RE: Bernhardt Sand and Gravel Pit, File No. M-2023-025,
112c Permit Application, Third Adequacy Review

1. Updated Exhibit F-1 and F-2 Maps

**PERIMETER GROUNDWATER DRAIN
(TYPICAL SECTION IF REQUIRED)**
N.T.S.

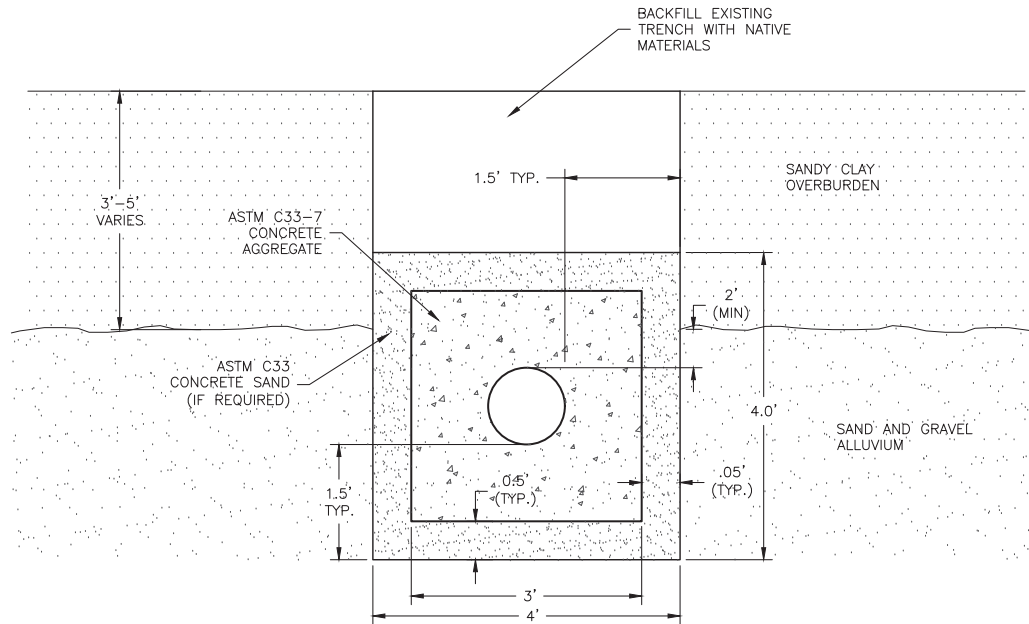
Maps showing the groundwater drain (including but not limited to Exhibit F) need to clearly show that they will be constructed. The words "if required" must be removed from the maps.

Response: Acknowledged. See Updated Exhibit F maps.
